ALPINE CITY PLANNING COMMISSION MEETING

SUBJECT: Public Hearing – Major Subdivision Concept Plan – Alpine Ridge Estates

**ALPINE CITY
STAFF REPORT**
August 29, 2019

Re: **Alpine Ridge Estates – CONCEPT**

Marsh Properties
Slope Analysis
Based on PRD formula
PRD Slope Analysis

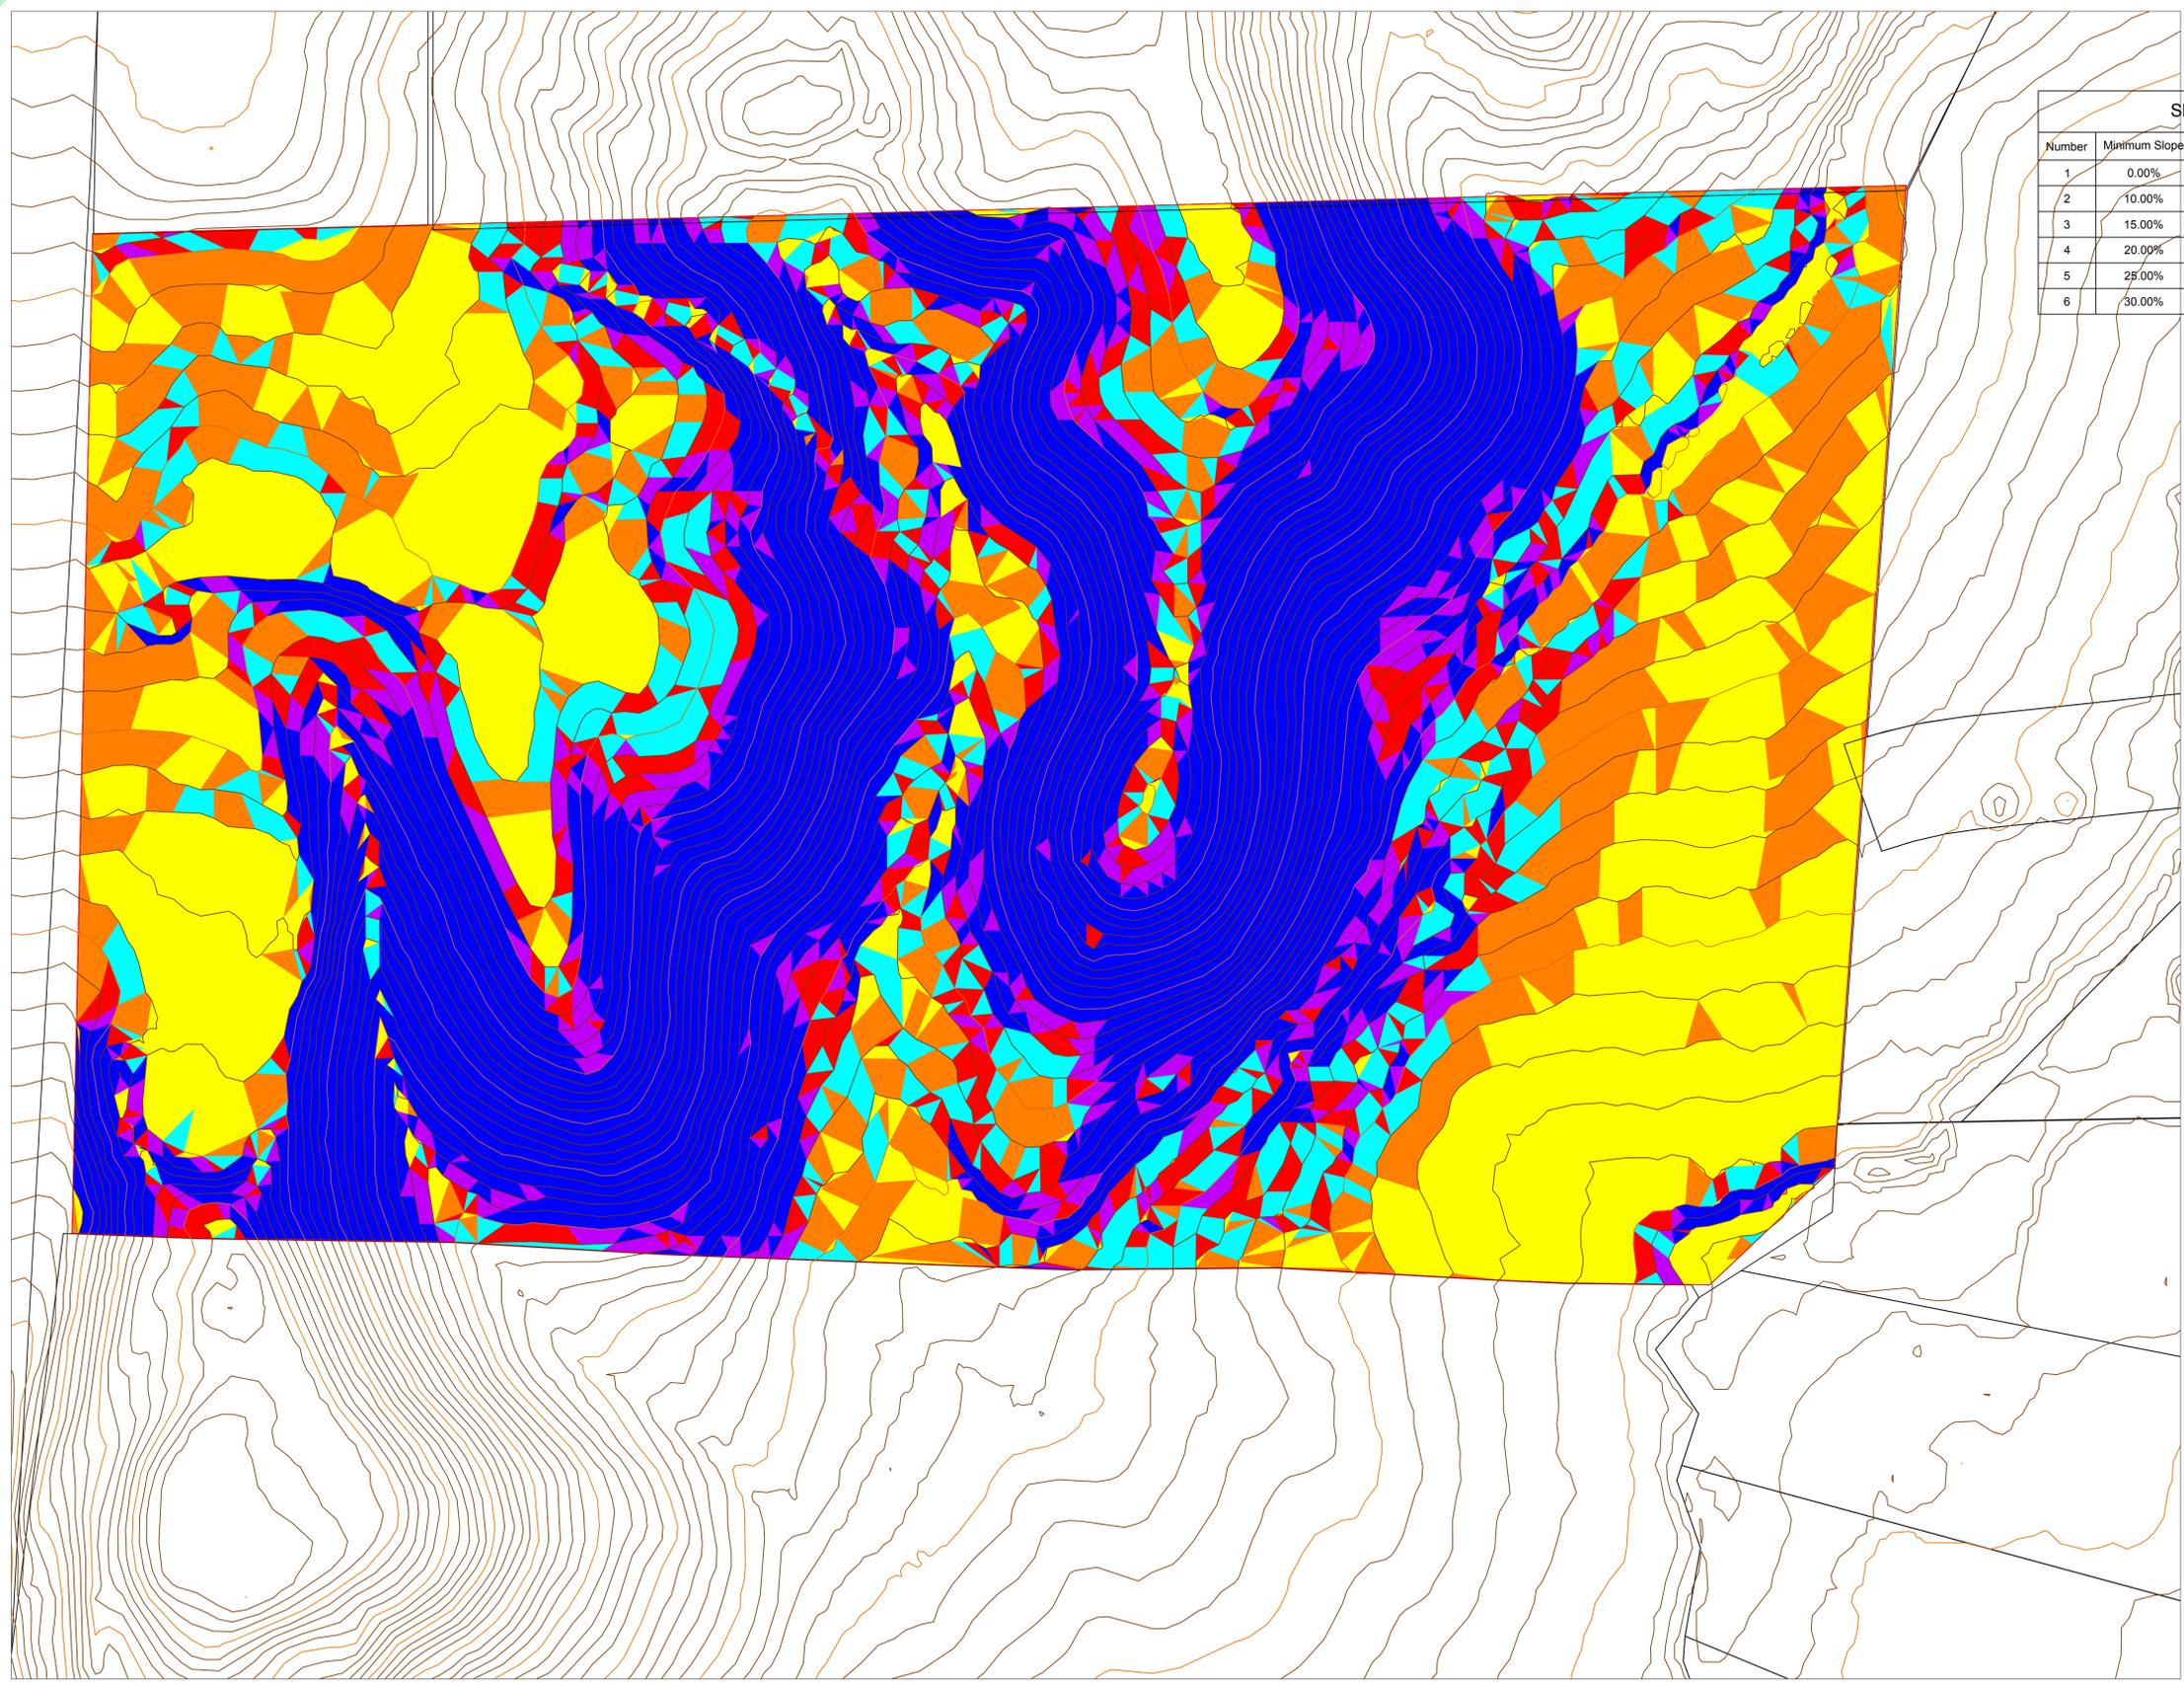
Every lot is required to show “Buildable Area” for a home. One of the requirements for Buildable Area is that “*The area contains no territory having a natural slope of twenty (20) percent or greater;*” (Section 3.01.110). Lots 3 through 5 have an existing/abandoned irrigation ditch that ran through the property which causes anomalies within the Buildable Area shown. **Staff would recommend an exception to the Buildable Area requirements on Lots 3 through 5 due to the topography being altered from the irrigation ditch.** If graded back to pre-irrigation grades, the area would clearly meet the ordinance.

If approved to be developed as a PRD, Development Code section 3.09.040.3 has strict requirements regarding open space. In general, this section states that all hazardous areas (rockfall, slide, flood, etc.) and all areas containing slopes greater than 25% must be included in the open space areas. Subsections of the same ordinance give allowances for lots to contain 25% slopes, but the applicant must show that they have first tried to follow the ordinance, and then show how their development would be better using the exception. A plan that meets ordinance without needing an exception to this ordinance was not submitted. **Staff would recommend the applicant bring a plan that meets the Open Space ordinance so the two concept plans can be compared. Staff has also not received data regarding the percentage of slopes greater than 25% are in each lot and would not recommend approval until the Planning Commission has seen this information.**

DRAWN TMS	CHECKED -	PROJECT # 19011
DATE 08/12/2019		SCALE 1" = 40'
SHEET C101		ENGINEER'S STAMP

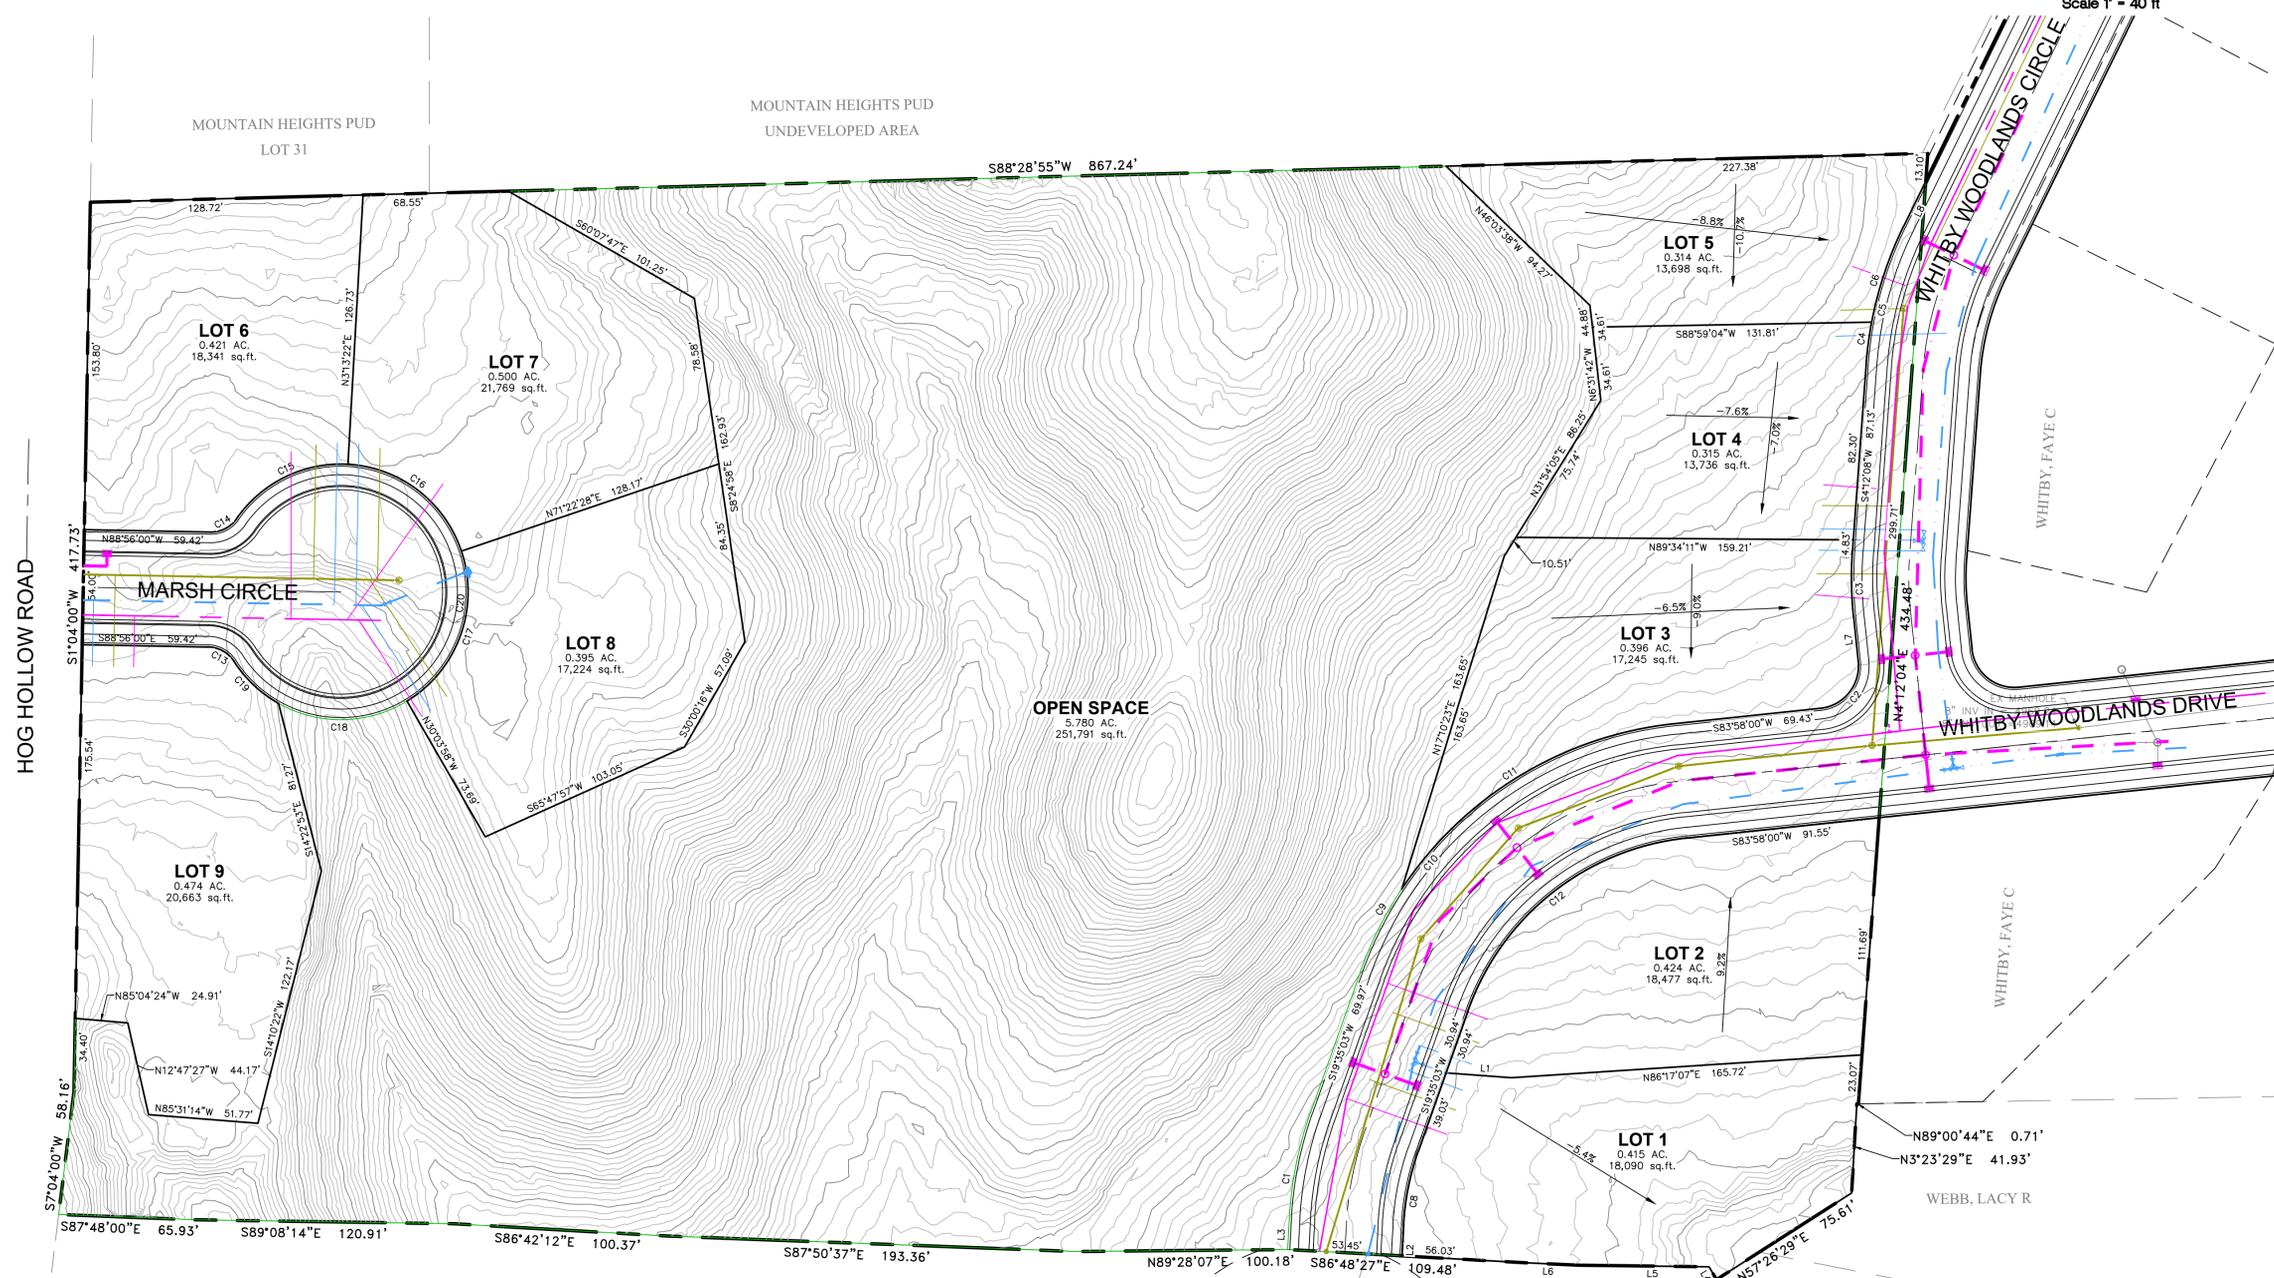
In review of the proposed concept plan for “Alpine Ridge Estates Subdivision”, dated 12 August 2019, please note:

- In the cover page or construction notes on Sheet C101 language needs to identify that this project is within the Wildland Urban Interface Boundary and as such is subject to compliance with the Alpine City Sensitive Land Ordinance.
- The temporary turnaround on Whitby Woodlands Drive to the south of lot 1 shall be an all-weather access road capable of sustaining the weight limits of fire apparatus as required in the International Fire Code.
- The area designated as open space shall be cleared of all dead fall, leaf litter, and standing dead oak in an effort to address fire spread mitigation.
- No vertical construction shall commence until water lines are tested, streets are accessible including turnarounds.
